ADDENDUM

Project Name: Renovations to Various Room Addendum No.: **TWO (2)**
Levelland ISD Date: November 2, 2009
501 Cactus Drive - Cactus Elementary Project No.: 09027.7
Levelland, Texas 79336

SUPPLEMENTAL DRAWING NO. SD-1

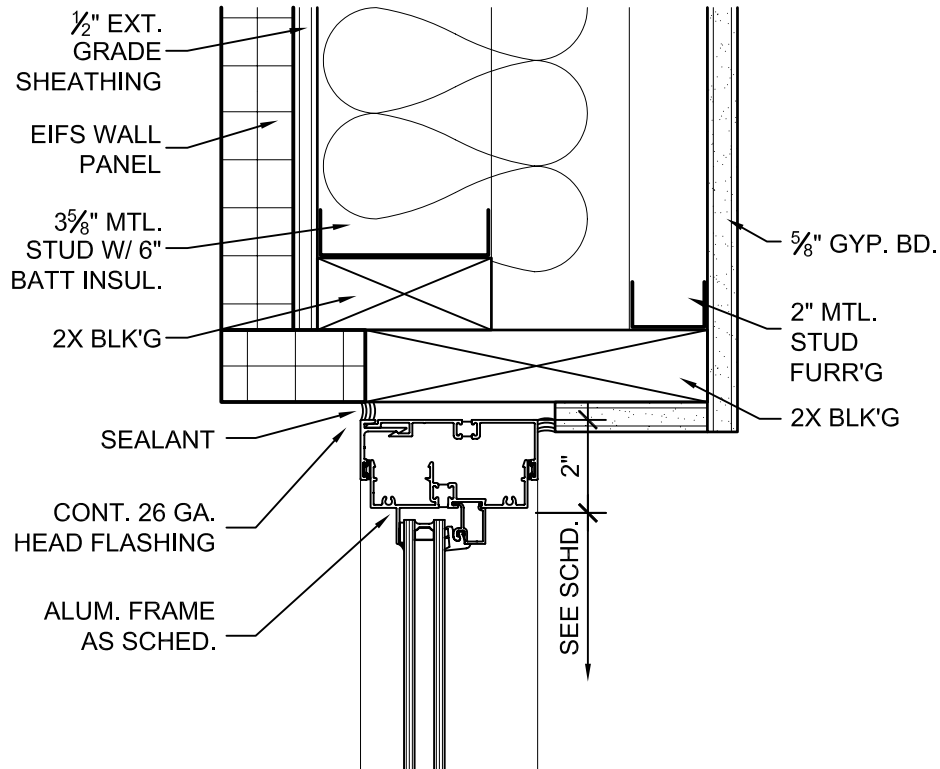
- A. Section 02 – revise section to omit window transom as shown in Supplemental Drawing SD-1 attached herewith.
- B. Section 03 – revise section to show ceiling height at 9'-0".
- C. Exterior Elevation 04 – omit transom above window. Provide EIFS wall finish as shown at adjacent wall finish.
- D. Detail 09 – revise detail to omit window and provide metal stud wall and EIFS finish as shown in Supplemental Drawing SD-02 attached herewith.
